STAFF RECOMMENDATION 1108 Lillian Street November 18, 2015

Application: Demolition, New construction - infill
District: Lockeland Springs-East End Neighborhood Conservation Zoning Overlay
Council District: 06
Map and Parcel Number: 08313013300
Applicant: Sandi Adams, Designer
Project Lead: Melissa Sajid, Melissa.sajid@nashville.gov

Description of Project: The applicant proposes to demolish the existing non-contributing house and to construct a new two-story duplex at 1108 Lillian Street.

Figure 2. Roof Plan

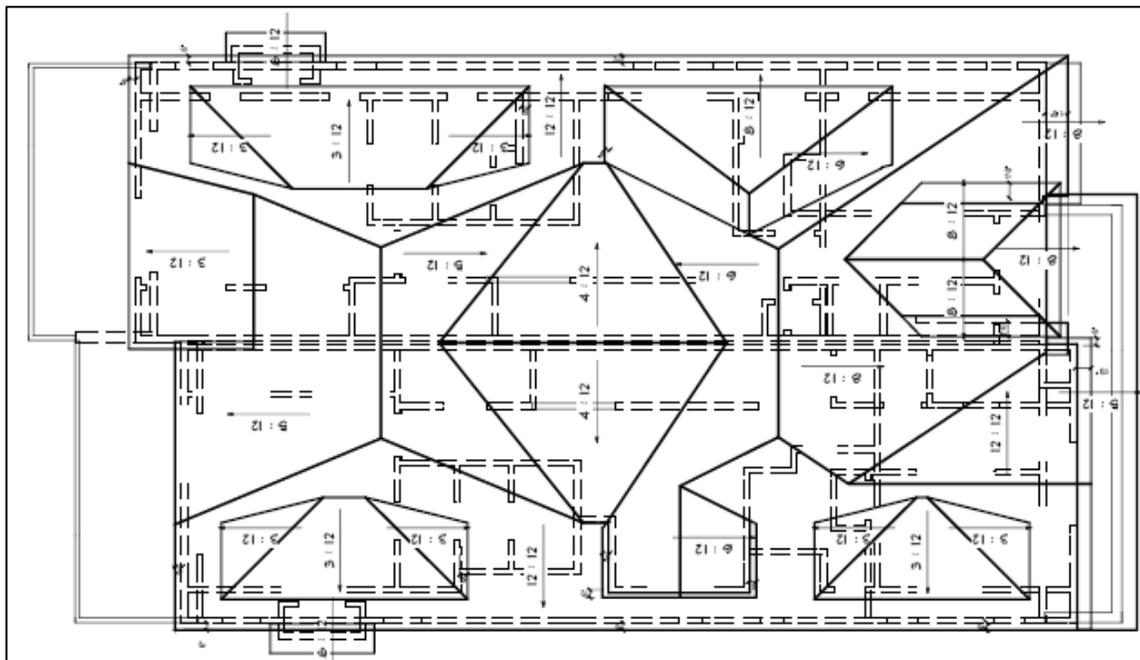
Roof Shape: The roof form, from the front, appears as a cross-hipped and gable form with a variety of pitches including: 3:12, 4:12, 5:12, 6:12, 8:12, 12:12. In actuality it is a much more complicated form that is atypical of the historic roof forms found in the district (See Figure 2).

The form is further complicated by a mix of both gabled and tall-hipped forms that do not correspond with the proposed roof principle roof form. Please see figure 3 for an example.

In addition, the front gabled dormer is parallel with the front wall of the structure; the guidelines require that the dormer be inset at least two feet (2') from the wall below.

Staff finds that the proposed roof contrasts greatly with both historic roof forms found throughout the district and recently approved infill and, therefore, is not compatible given the context. Staff finds that the infill does not meet Section II.B.5. of the design guidelines.

FRONT
LEFT
ELEVATIONS

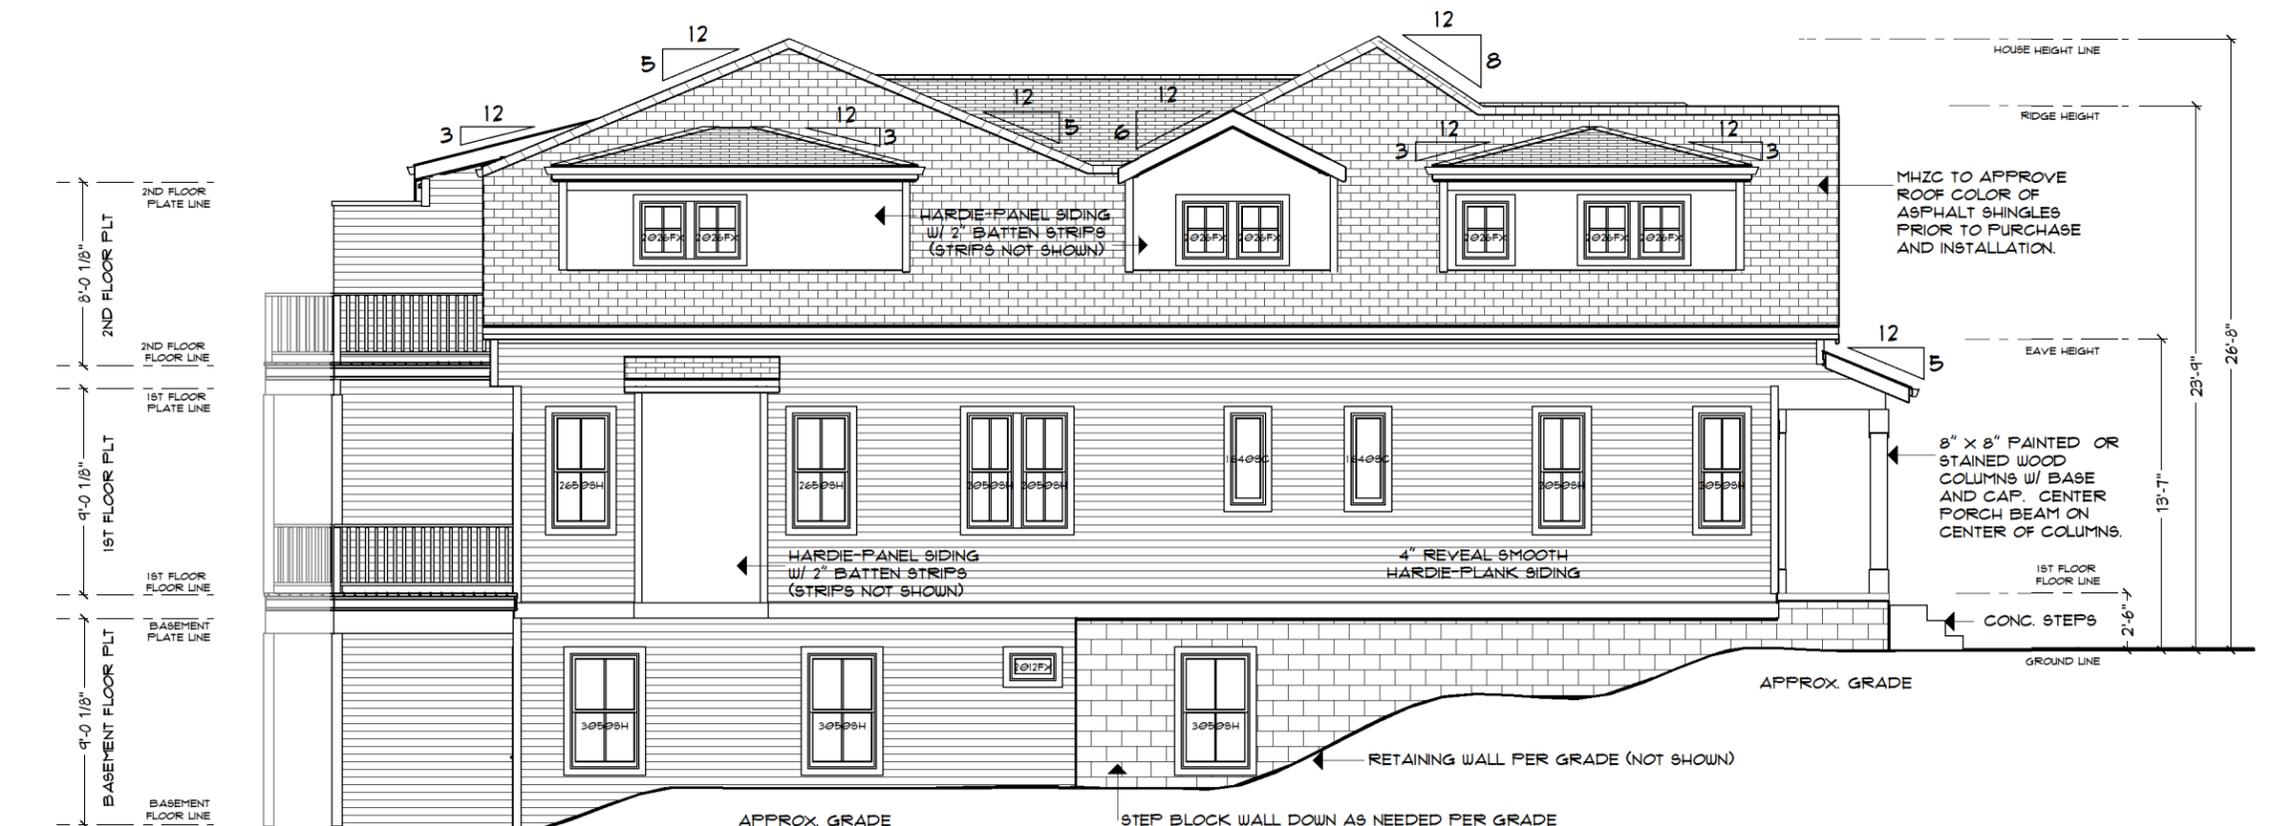
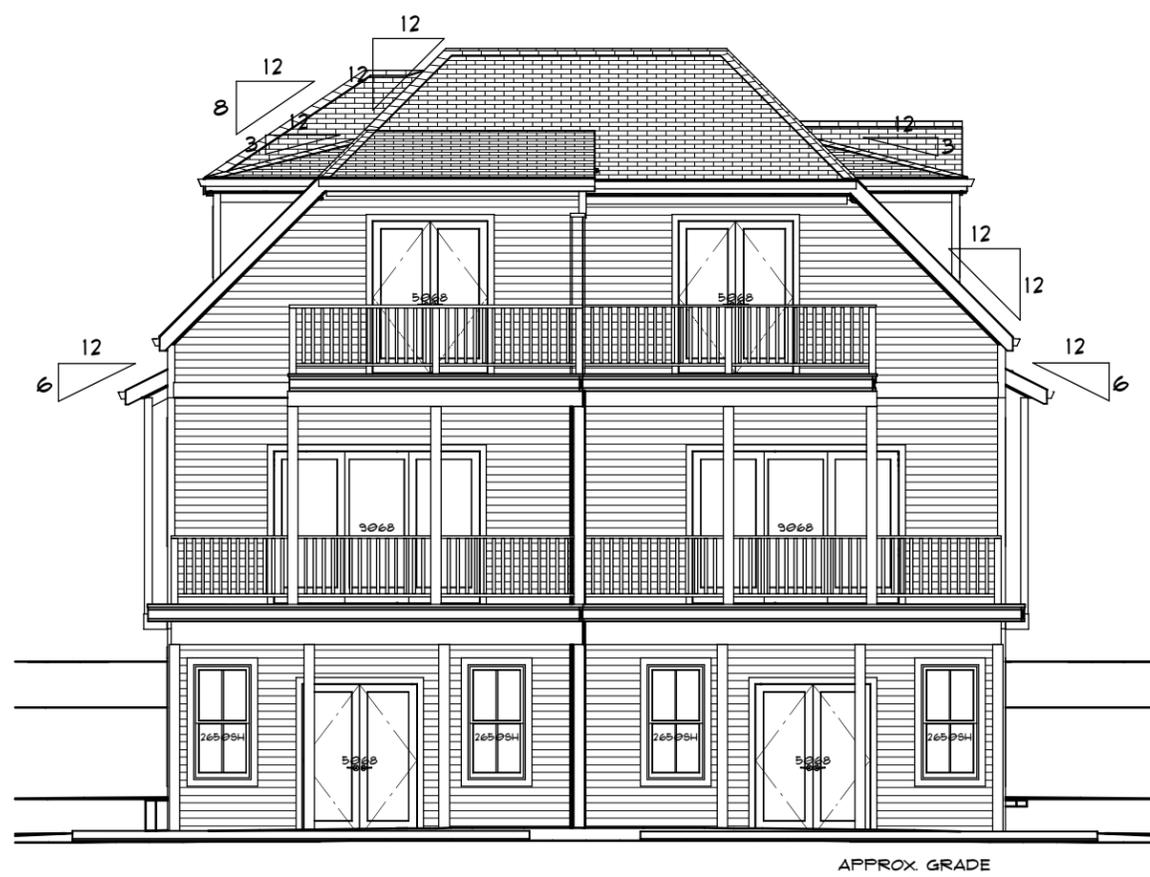
Although the overall height is appropriate, the tall roof form and tall eaves (13' 7") together result in a home that is really two-stories rather than the one and one-half stories that is more appropriate for this area of the neighborhood.

Looking at other infill approved on this block, eave heights have been primarily 12' and under with the exception of 1112 and 1114 which are much smaller homes constructed on narrower lots than the typical lots found in this area. Staff finds that the project does not meet section II.B.1 for height.

The proposed form has two different porches. One that is rectangular next to another one that is deeper and square. Typically, duplexes have a shared porch or two different porches or stoops of equal dimensions and design, making the building look like one building. Two different porch dimensions begins to make the house look like two different buildings side-by-side rather than one building as seen historically. In addition the left porch is only five feet (5') deep and the Commission has previously required that porches be at least six feet (6') in depth to provide adequate useable space.
